148. PLCA Reconciliation Sublayer (RS)

148.4.7 Dynamic PLCA (D-PLCA)

Figure 148–3—PLCA Control state diagram, part a

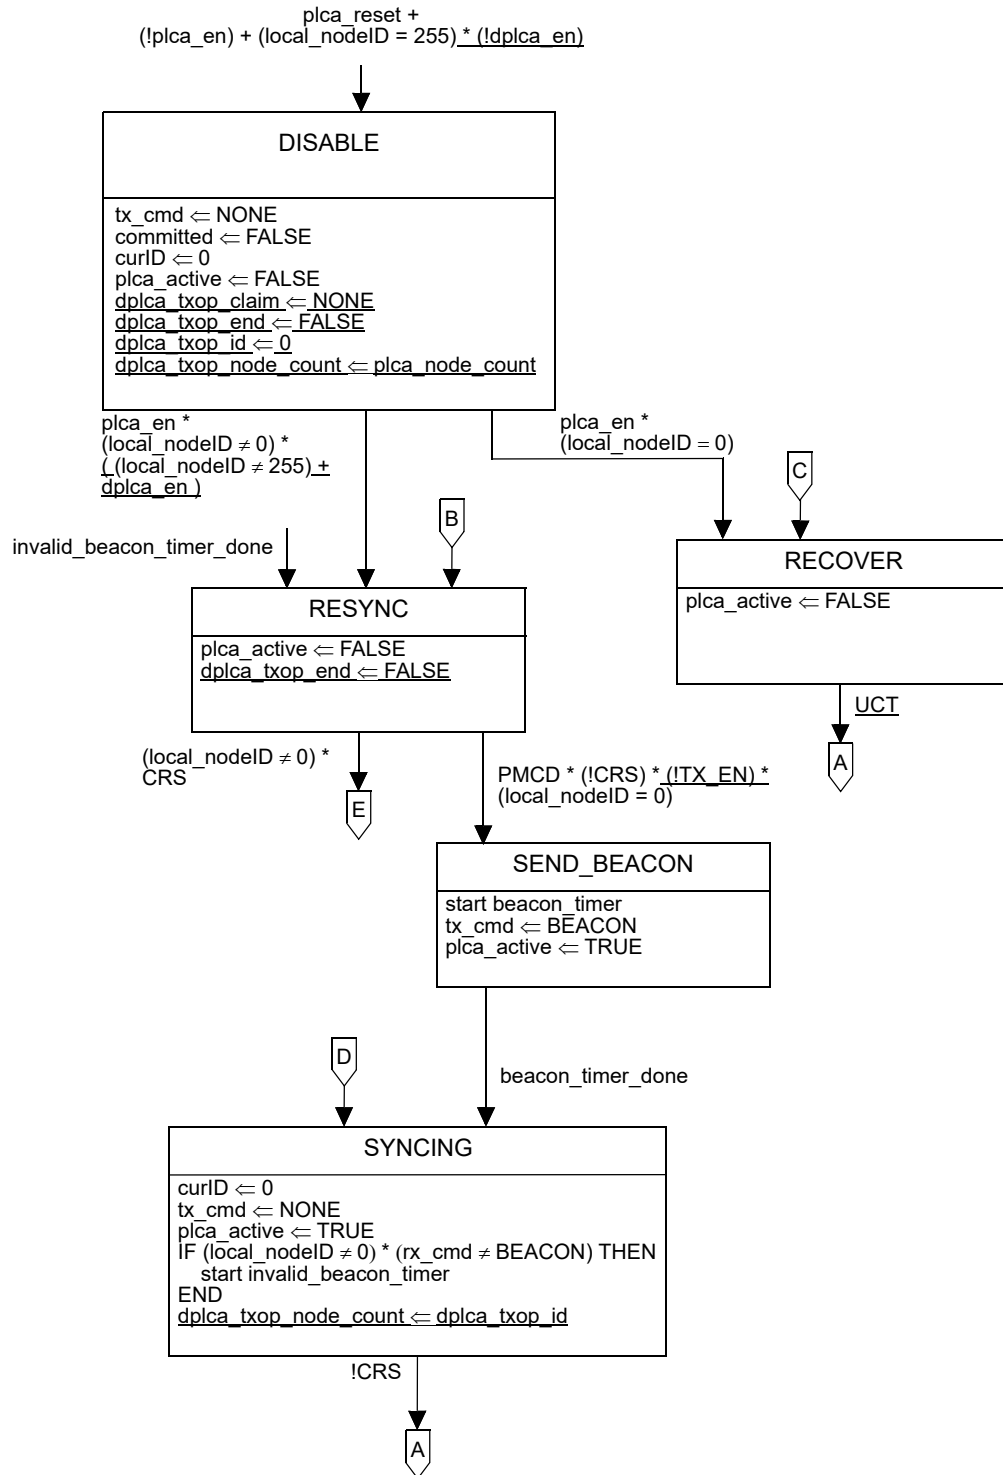
Replace the arc from BURST to TRANSMIT in Figure 148-4 with tag F, replace the arc and the text “ELSE” from NEXT_TX_OPPORTUNITY to WAIT_TO in Figure 148-4 with tag G, and change Figure 148-3 and Figure 148-4 as shown:

Figure 148-5—PLCA Data state diagram, part a

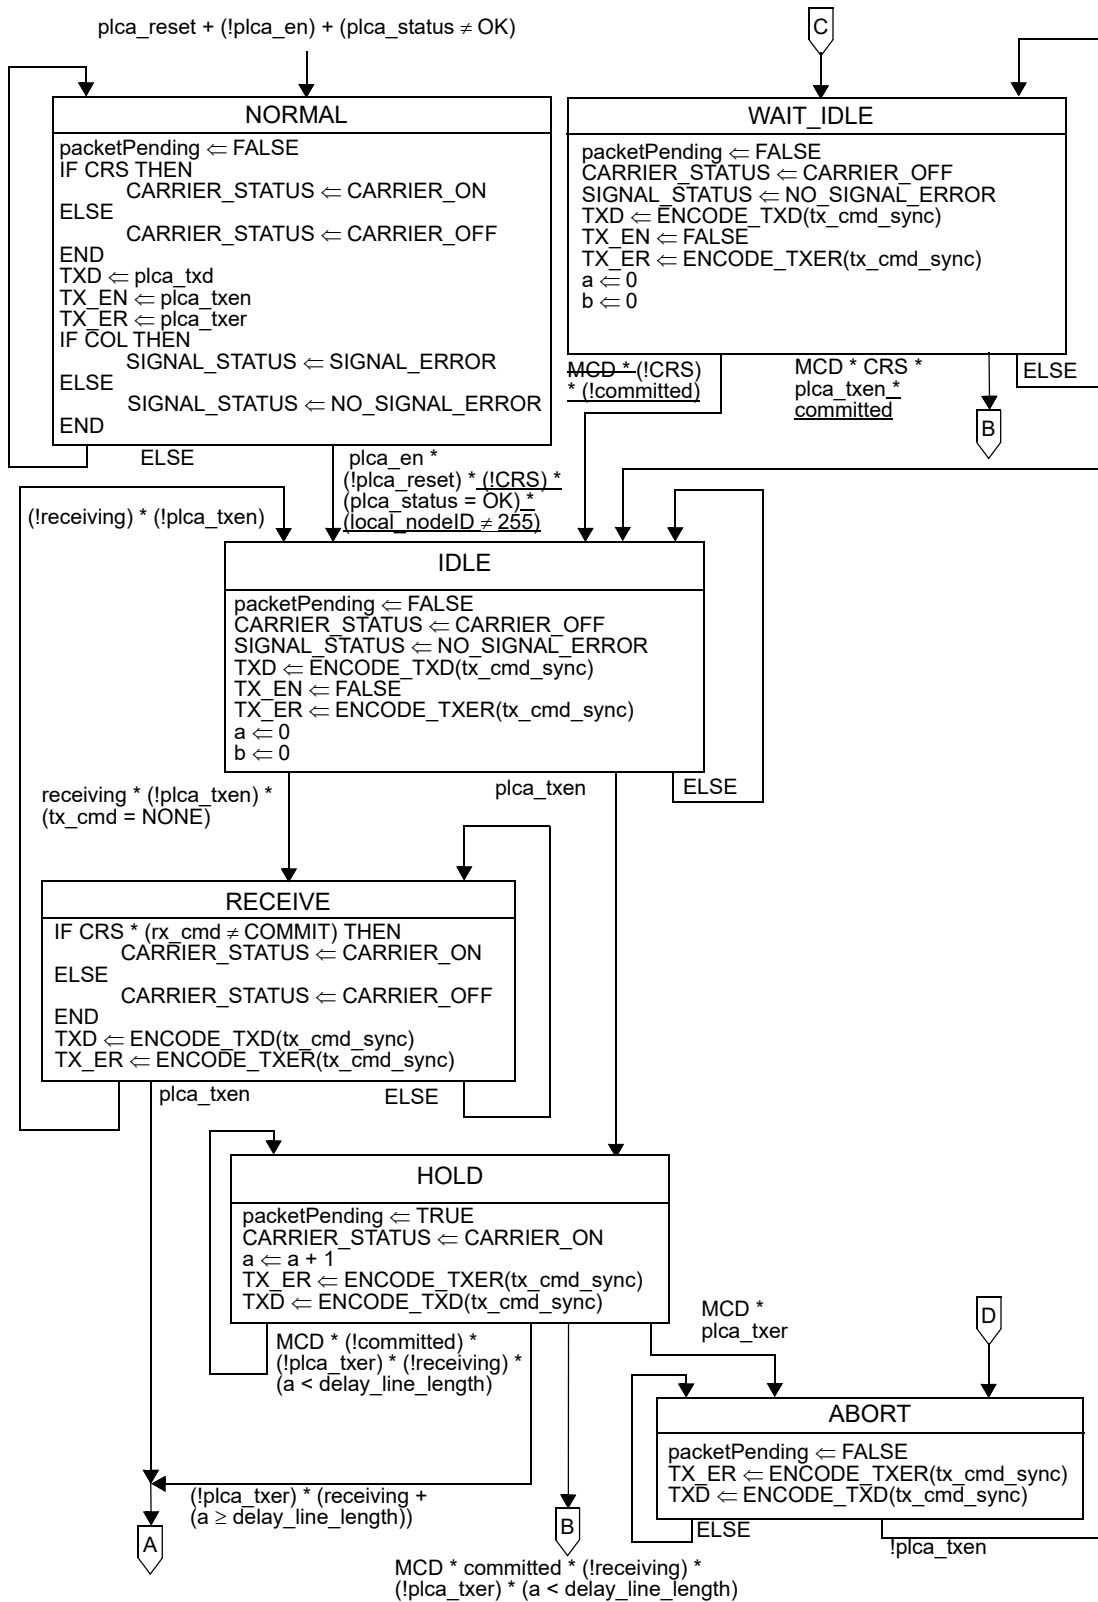
Change Figure 148-5 and Figure 148-6 as shown:

Figure 148–8—D-PLCA Control State Diagram

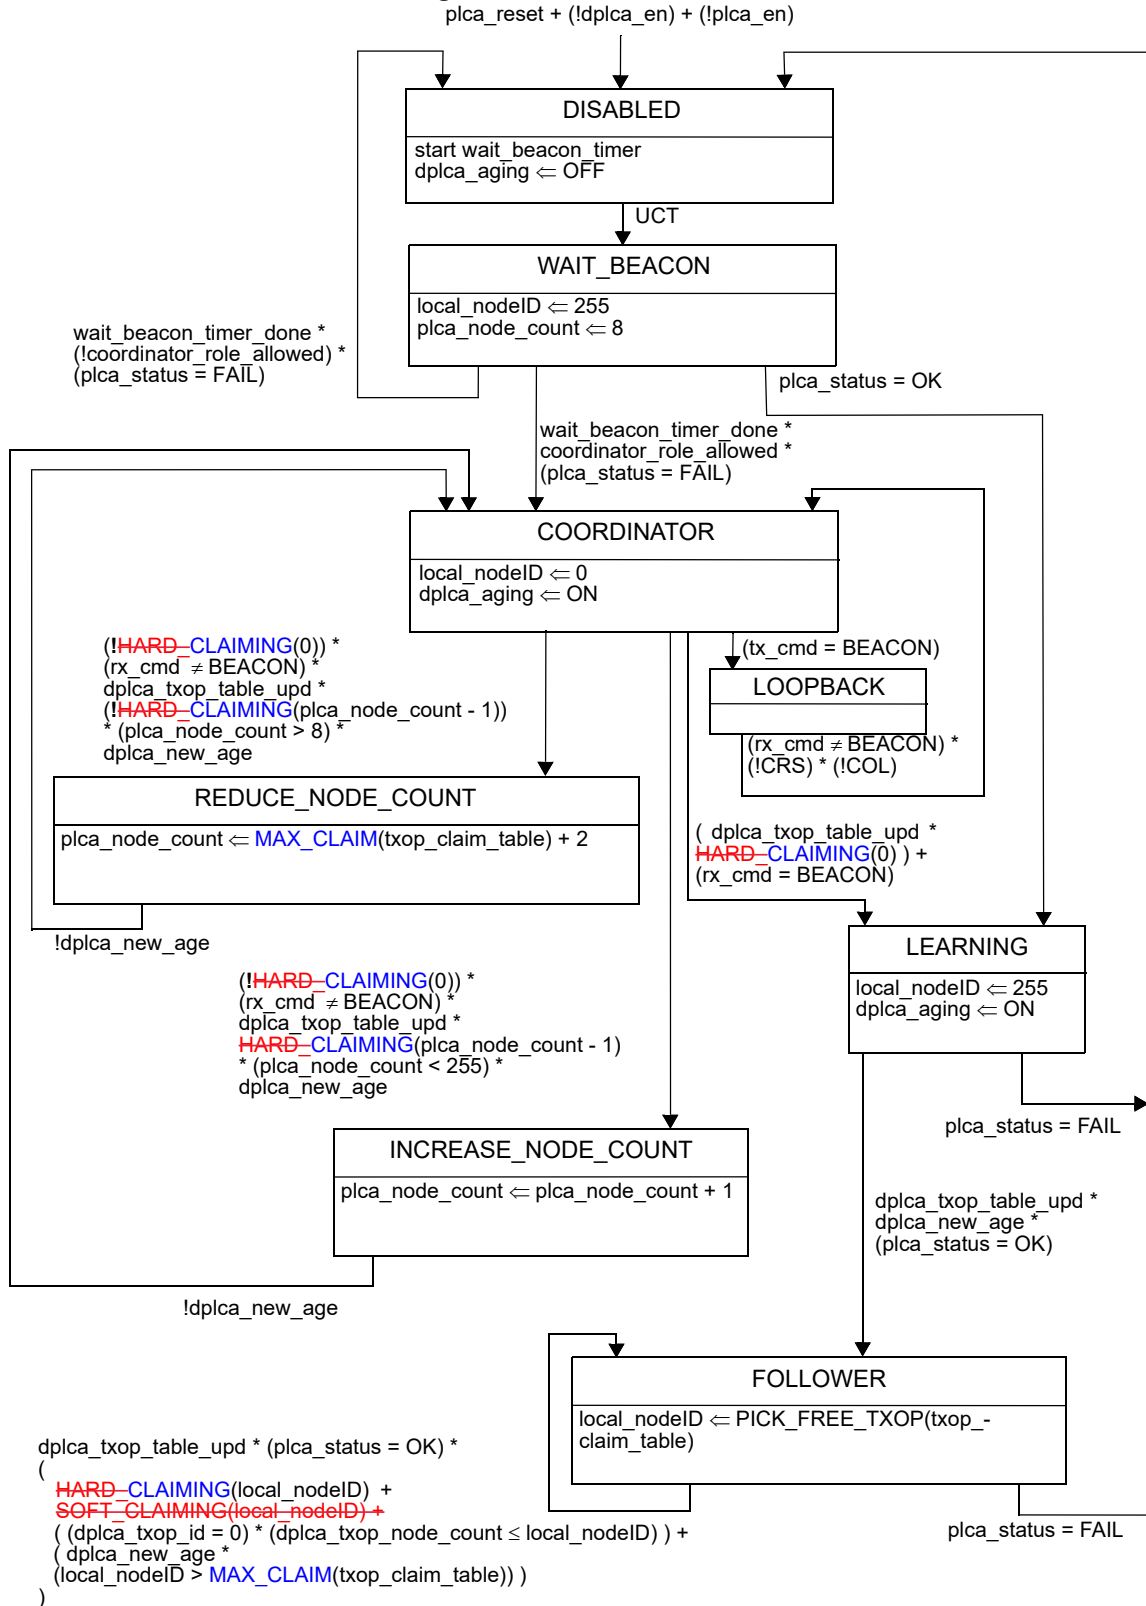
Insert new subclause 148.4.7 (and Figures 148-8 and 148-9) after 148.4.6 (and its subclauses) as follows:

D-PLCA is an optional feature of the PLCA RS that reduces the amount of configuration required to use PLCA. D-PLCA enables nodes to select unique node IDs automatically and defines a method to designate a single node with ID = 0 (coordinator). If the D-PLCA option is implemented, it shall comply with the state diagrams in Figure 148-8 and Figure 148-9.

Figure 148–9—D-PLCA Aging State Diagram

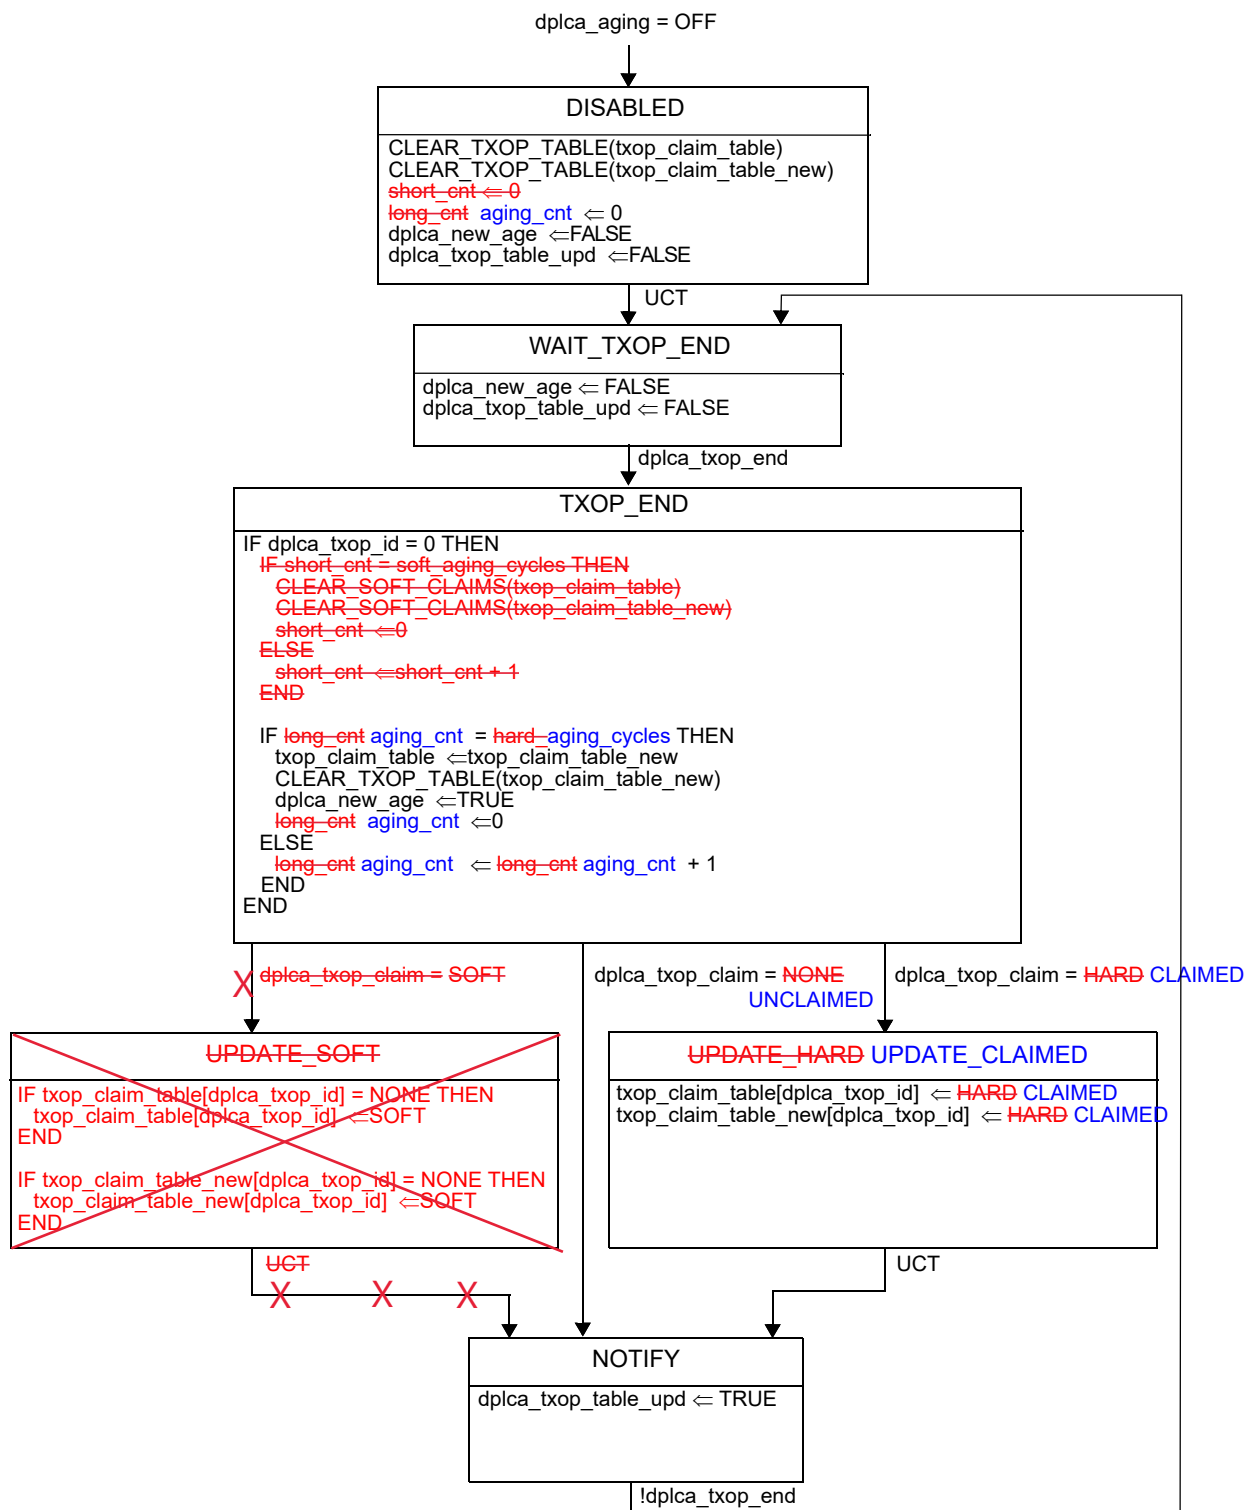
39
The transmit opportunity table is maintained by the D-PLCA aging state diagram defined in Figure 148–9.	40
Values: Array of 255 elements, each having a value of NONE, SOFT or HARD.	41
	42
	43
	44
	45
	46
	47
txop_claim_table_new	48
Copy of txop_claim_table used by the D-PLCA Aging State Diagram to handle the expiration of HARD claims.	49
Values: same as txop_claim_table	50
	51
	52
	53
	54
